SUBJECT: Grand Gulf Nuclear Station
Unit 1
Docket No. 50-416
License No. NPF-29
Inservice Inspection Plan Relief
Request
AECM-88/0104

Attached are two revised Relief Requests (I-00007, Revision 1 and I-00010, Revision 2) and one new Relief Request (I-00019, Revision 0).

GRAND GULF NUCLEAR STATION
UNIT 1
RELIEF REQUEST NO. I-00007 REVISION 1

GRAND GULF NUCLEAR STATION
UNIT 1
RELIEF REQUEST NO. I-00019 REVISION 0

FIGURE 1

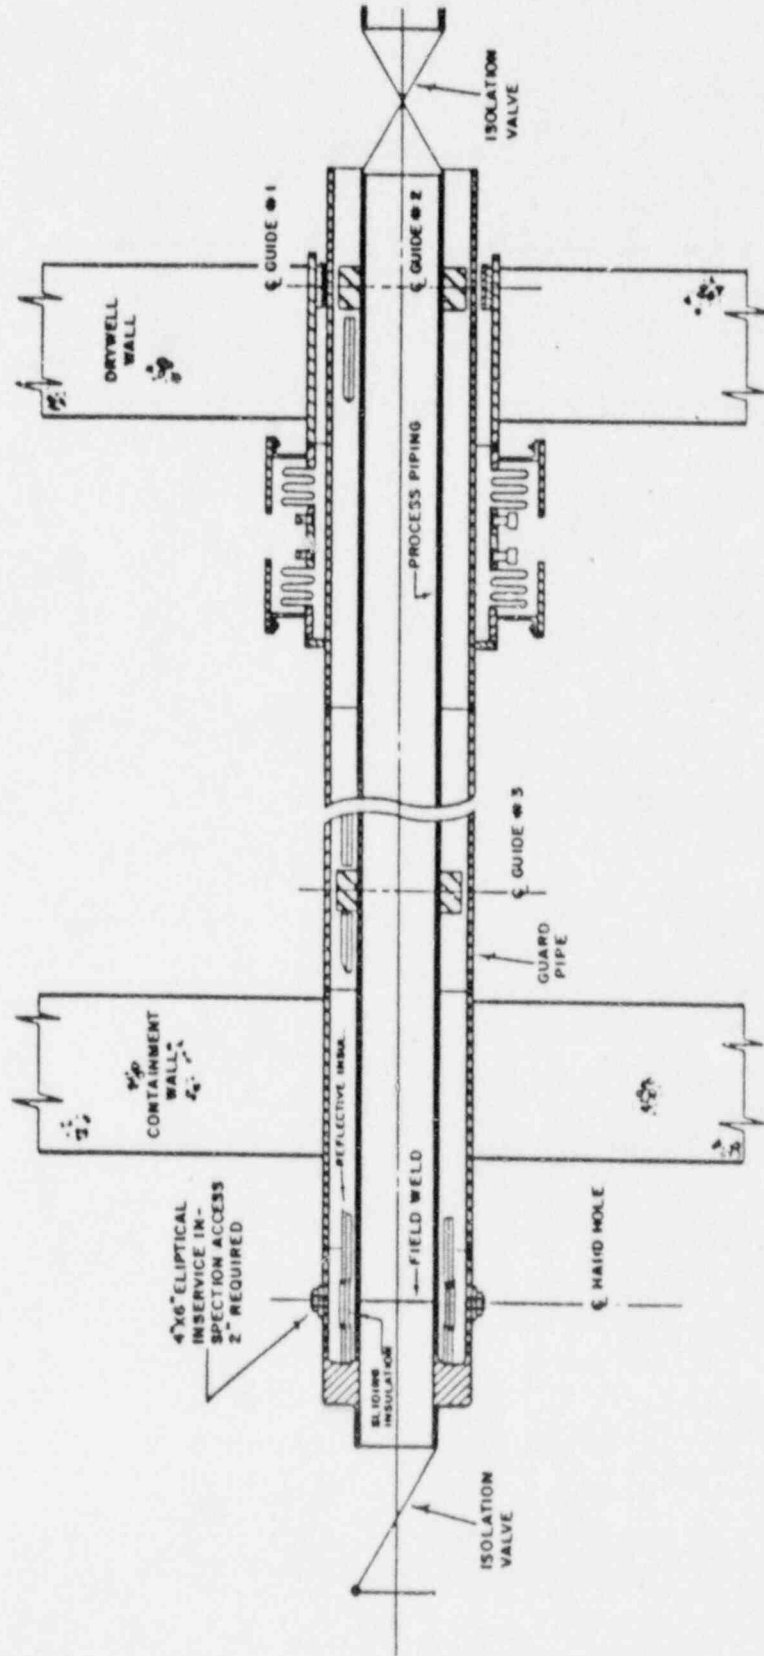
- IV. Information to support the determination that the code requirements are impractical: The circumferential welds joining the flued head and the process pipe are encapsulated by the portion of the guard pipe which protrudes beyond the containment. To comply with the inservice inspection requirements of ASME Section XI, two 4" x 6" elliptical access ports spaced 180° apart are provided for access to the welds. During the development of the access port design, the inservice contractor had indicated that the ports were adequate to permit performance of surface and ultrasonic examination of the entire weld. After fabrication and installation of the process pipe, guard pipe and the flued head, it was determined that the entire length of the weld is not accessible through the two access ports.

Permission is requested to perform ultrasonic examination of the welds listed in Table 1 to the extent possible through the 4" x 6" access ports. Also, permission is requested to perform the code required surface examinations on the same welds to the extent possible through the access ports. The percentage of each weld examined will be recorded during the inservice examination.

- VIII. NRC Discussion Statements (Revision 0) continued
- (a) the volumetric and surface examinations are performed to the maximum extent practical and
 - (b) the Code-required surface examinations and system pressure tests are performed, and visually inspected.

FIGURE 1

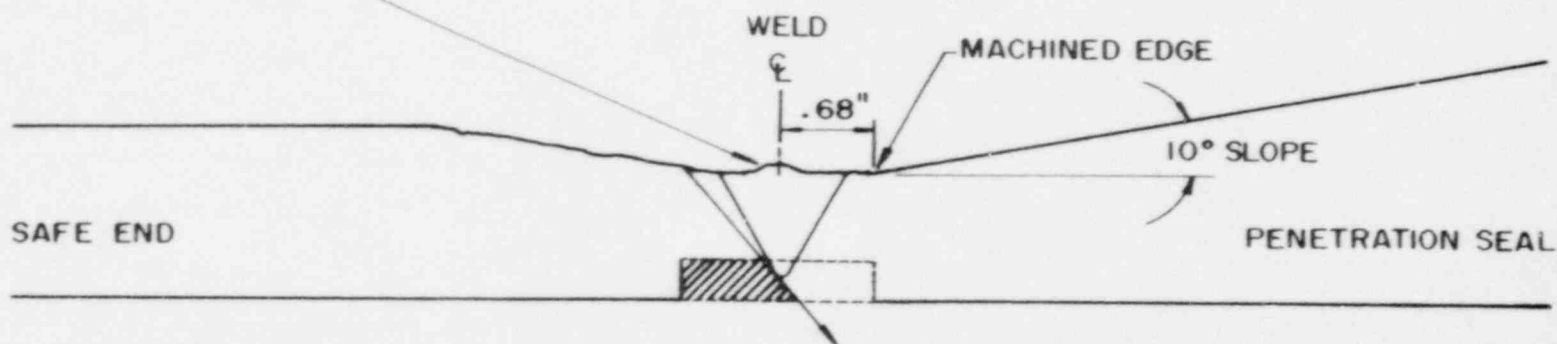
The weld is volumetrically examined from the safe end obtaining 44.7% coverage of the code volume. Examination from the weld and from the penetration seal side of the weld is prohibited due to component configuration and weld geometry (see figure 1).

N9 A & B
SAFE END TO PENETRATION SEAL
44.7% EXAMINED IN ONE DIRECTION

HUMP AT ϕ OF WELD PREVENTS SCANNING
COMPLETELY ACROSS WELD

CODE VOLUME FOR VOLUMETRIC EXAMINATION = .228 IN²

EXAMINABLE VOLUME FOR VOLUMETRIC EXAMINATION = .102 IN² or 44.7%

Permission is requested to perform the Code required volumetric examinations to the extent described above and shown in figures 1 and 2.

FIGURE 2

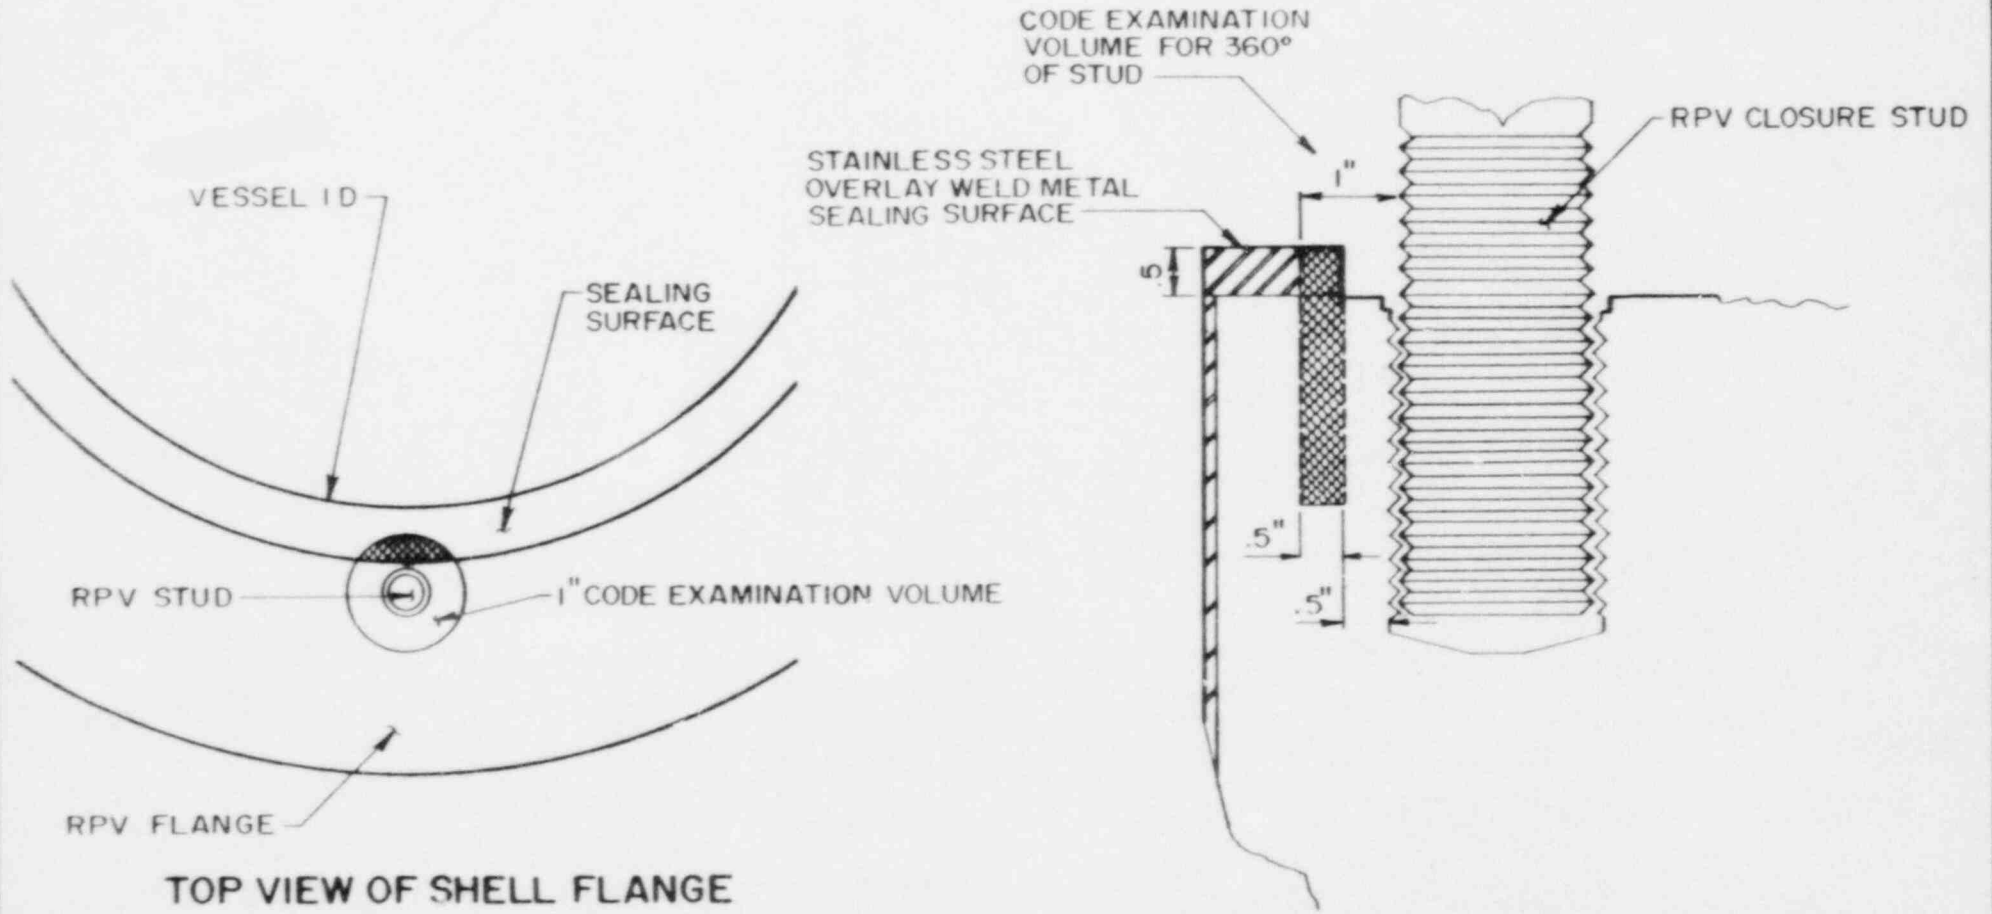
2. The area of the RPV flange requiring relief is located between the stud hole and the RPV inside diameter (ligament area). The ligament area also contains the sealing surface that makes contact with the RPV head flange. The seal surface is comprised of deposited weld material, and raised approximately 1/2 inch above the flange face creating a geometrical obstruction.

A code volume of 96% is volumetrically examined without interference with the seal surface. The remaining 4% is contained within the restricted area associated with the seal surface (see figure 2).

UNABLE TO SCAN FULL 1" CIRCLE AROUND STUD HOLE
